# **Seismic Evaluation of the U1a Complex at the Nevada Test Site**

## ***Interim Report*** **SM98-24**

**November 4, 1998**

**Figure 25:** Groups of the instrumentation cabinets rest on timber blocks in the U1g Users Alcove.

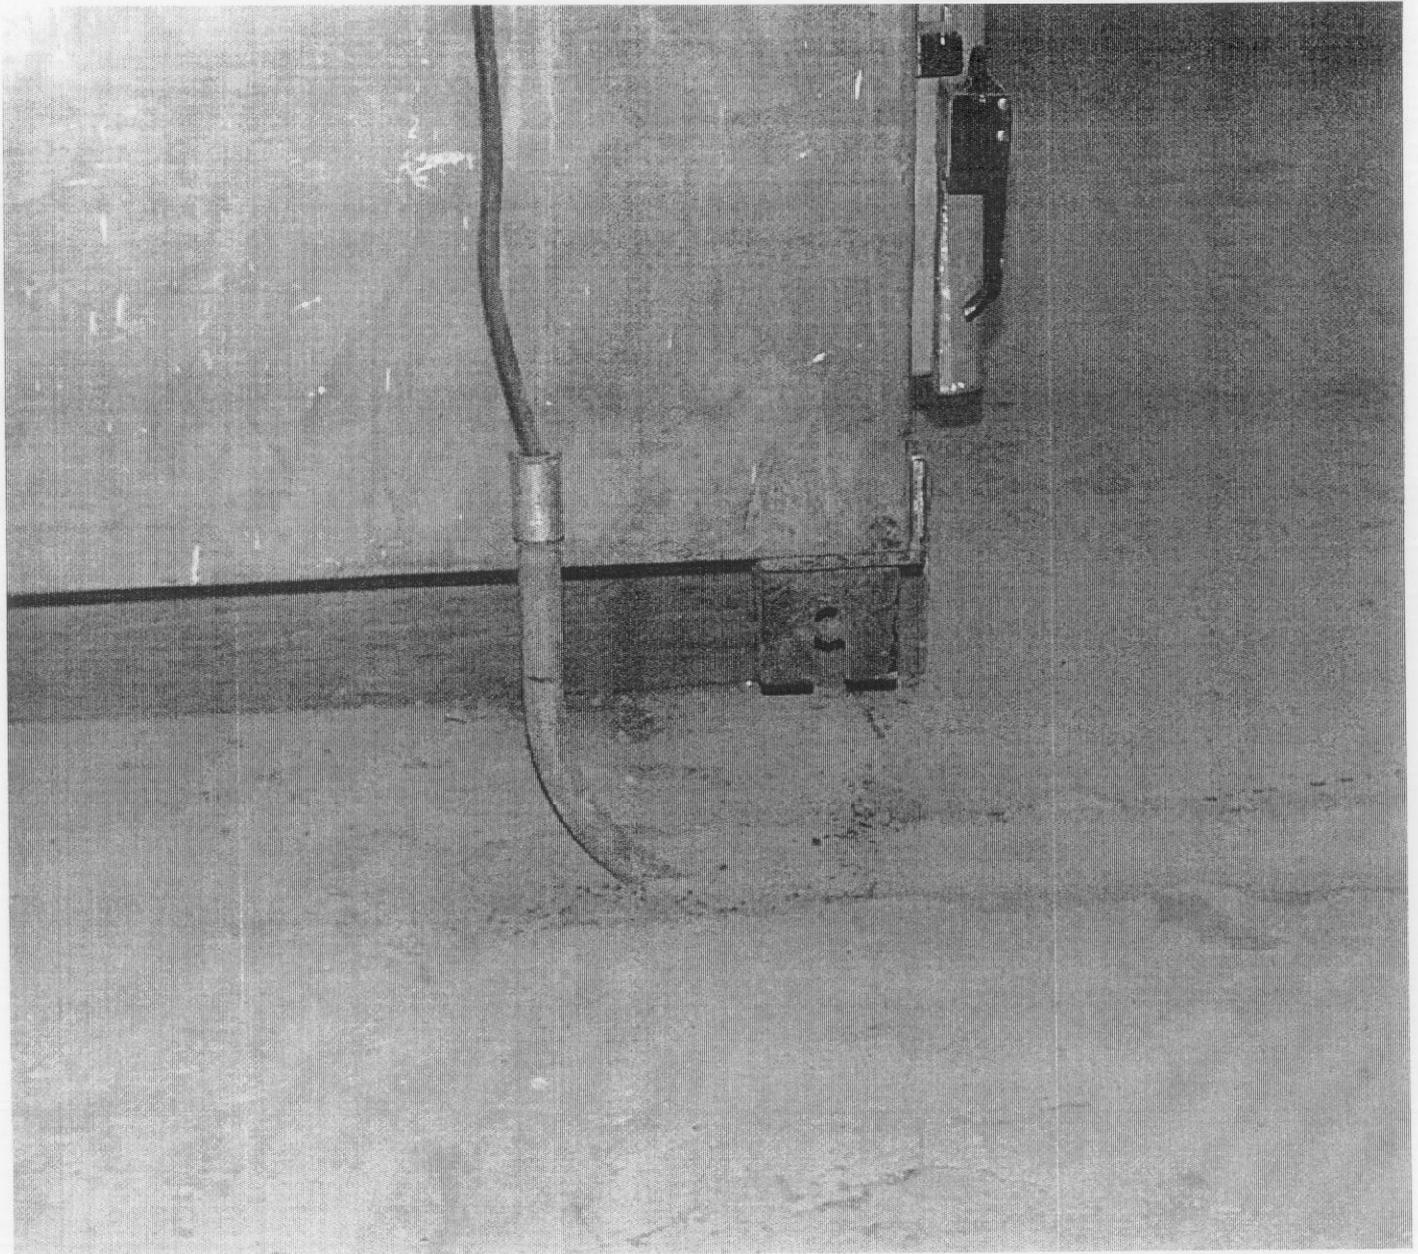
Figures 24 and 25 were taken in the DX-12 Alcove and U1g User Alcove, respectively. In these two alcoves, groups of instrumentation cabinets rest on timber blocks. The groups of cabinets might not overturn due its large foot print and restraint provided from the cables connection at the

top of the cabinets. However, evaluation is recommended to determine the stability of the cabinet group to ensure that the cable will not be separated from the instruments.

Figure 26: A typical anchorage for cable trays.

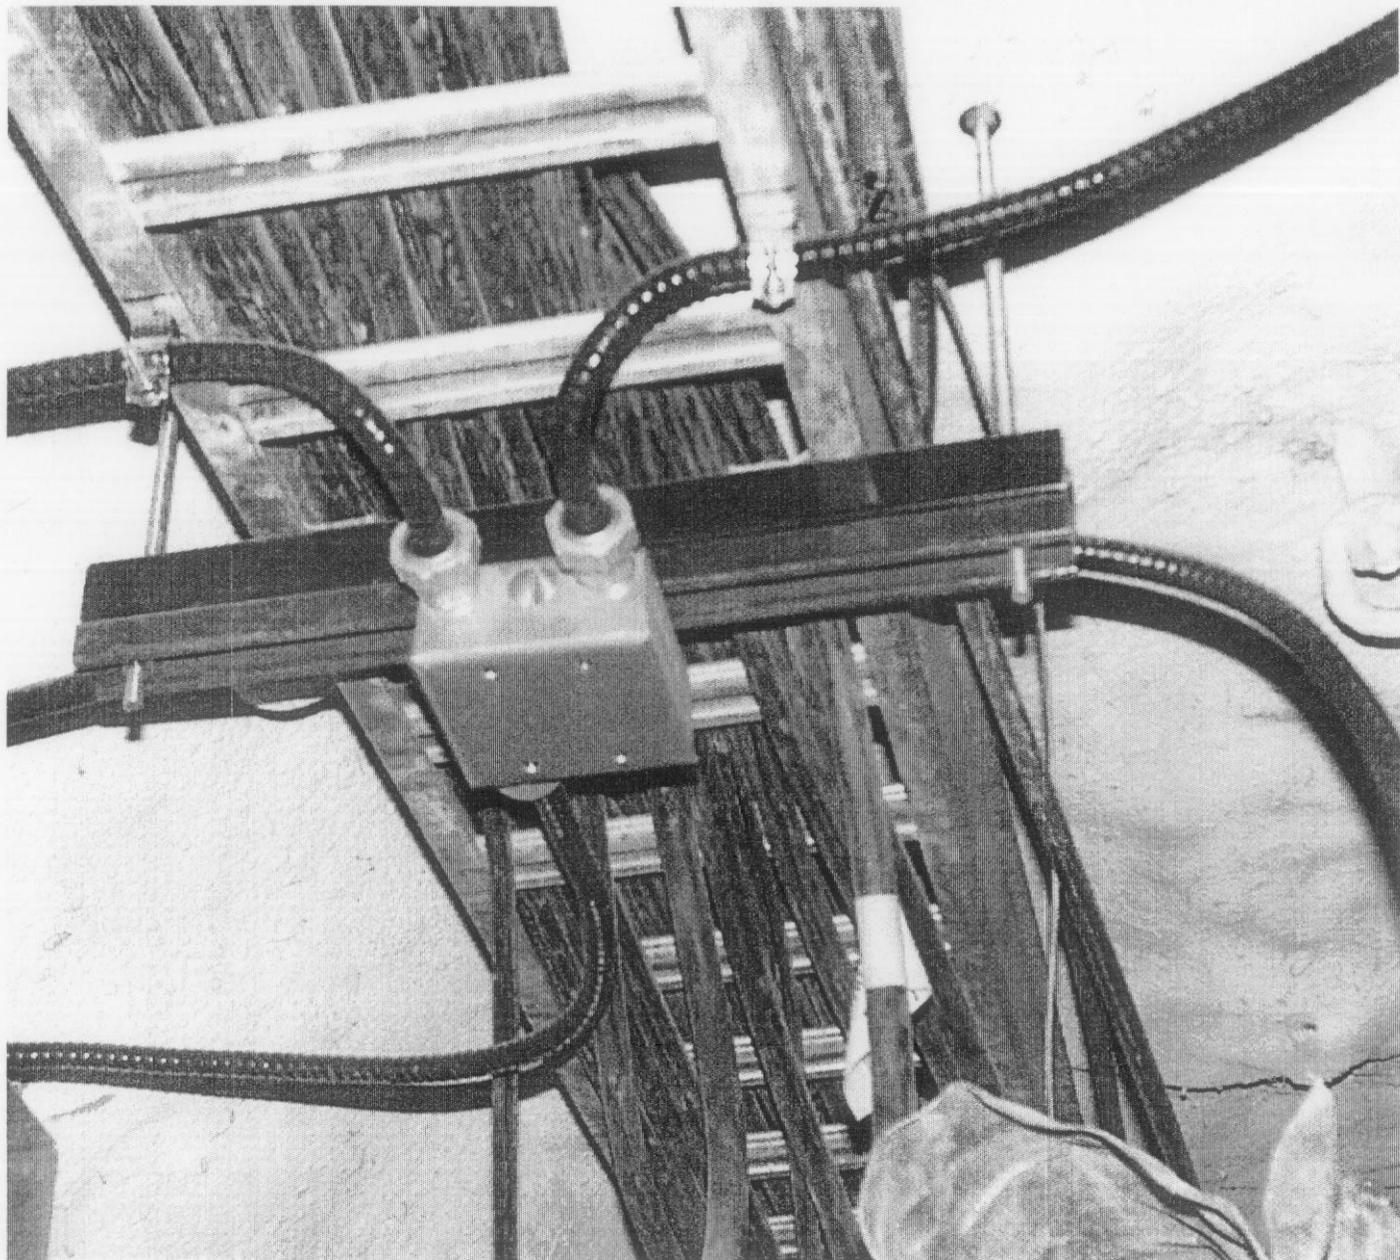
Typical cable tray anchorage is shown in Figure 26. Note that the tray is supported on two vertical rods. No lateral support is seen in this cable tray. Double deck cable trays are used in DX-12 and U1g Users Alcoves. They are also supported off the ceiling with rods and unistruts. Only one lateral support was found in the entire cable tray system in DX-12 Alcove. It is not clear this lateral strut is adequate for the entire system. Similar evaluation is also needed for the cable trays in U1g Users Alcove.

**Figure 27: An A/C unit sits on four wheels and is connected to two ducts.**

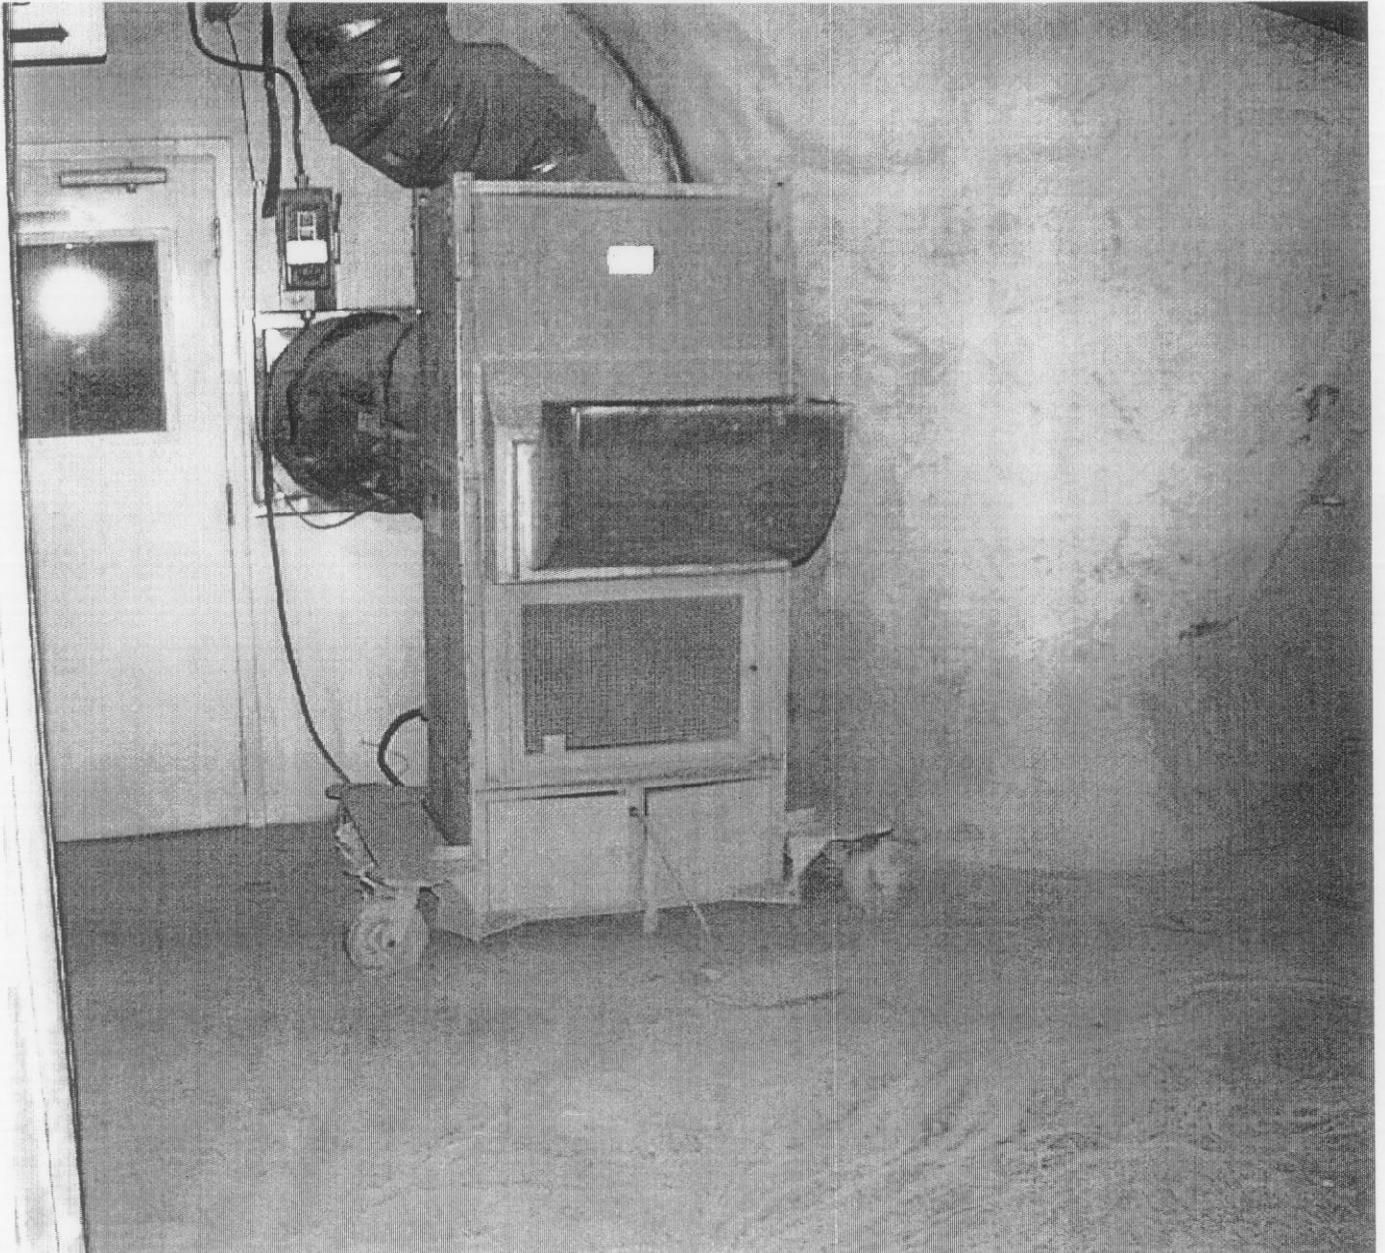
Some heavy equipment rests on platform on wheels. For example, Figure 27 shows an A/C unit rests on wheels. It is not sure that the ducts can provide restraint to the unit or that the ducts may be separated from rolling unit.

Figure 28: Multiple cable bundles are supported by U-shape hog wire.

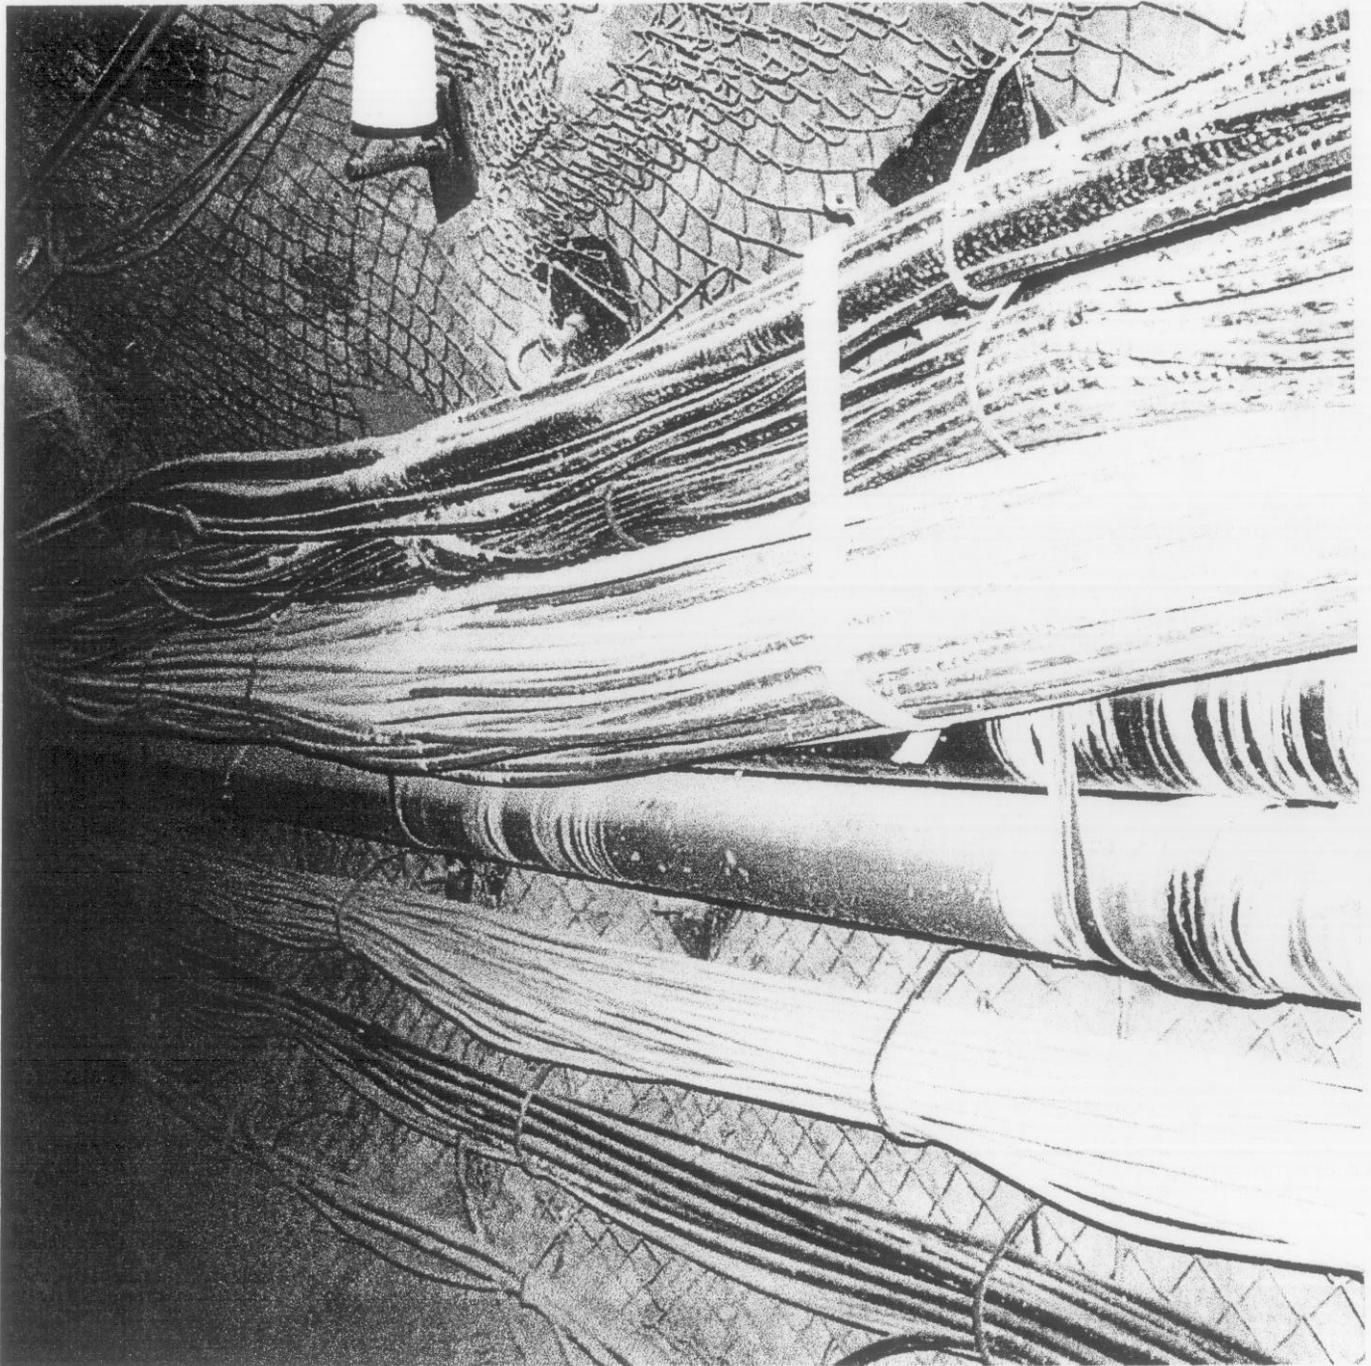
Heavy mining and construction were in progress during the walkdown. Several items were identified that proper anchorage was required after the construction was completed. Installation of new conduit for cables was also in progress. Figure 28 was taken along the 02-drift showing programmatic cable bundles along the drift wall. It was understood that many cables held by removable U-shape hog wires along the tunnel walls would be replaced with permanent supports.
